Project	COUNTRY FLATS, SANDFIELDS
Project number	N297
Client	HALE CONSTRUCTION LTD
Title	BLOCK 05/06 ELEVATIONS 2/2
Drawing number	A016
Scale	1 : 100 at A1
Revision	J
Status	INFORMATION
Drawn	PC
Date	30.11.21

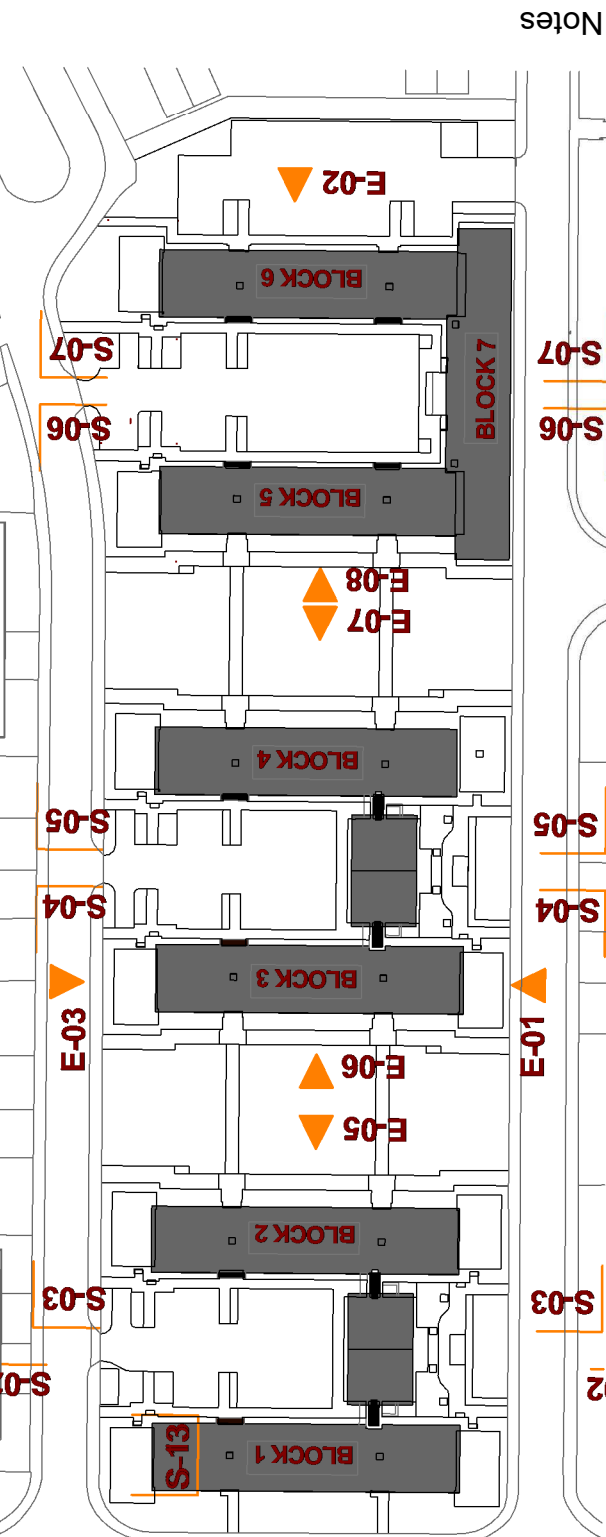
1. Modular end links re-positioned slightly off existing buildings, with the party wall
construction can be achieved off site.
2. Windows have been slightly re-positioned to the new build to suit the structural
design of the modular units and the constraints of the timber frame.

3. Parapet to modular end blocks have been lowered by approx 900mm to comply
with the structural wind loadings and timber frame design.
4. Corner windows have been removed and replaced with 2no. Windows on either
corner, again due to the structural and timber frame design of the blocks.

5. PV panels have been omitted from the end and modular units to suit the structural
and timber frame design of the blocks.
6. Ground floor Juliet balcony added to existing flats to provide better security
whilst ensuring the open areas remain as communal spaces.

7. Air source heat pump external louvre enclosure amended to be single storey over
entrance canopy to end link blocks.
8. External air source louvre enclosure handed to provide internal riser/access
requirements for maintenance.

9. Bugby/cycle store added to block 6 and 7 parking courtyards, with bin store
near block 6 amended in size to suit located of bedroom window.
10. Bin stores slightly re-positioned to suit existing drainage runs.

11. Footpaths amended to be Tarmac.
12. Windows in communal area to the linked blocks made narrower to ensure
1.8m fire separation distance to existing windows is achieved to comply with
building regulations.

13. 1no. window in block 7 communal area either side of stairwell removed to
ensure 1.8m fire separation distance to existing windows is achieved to comply
with building regulations.
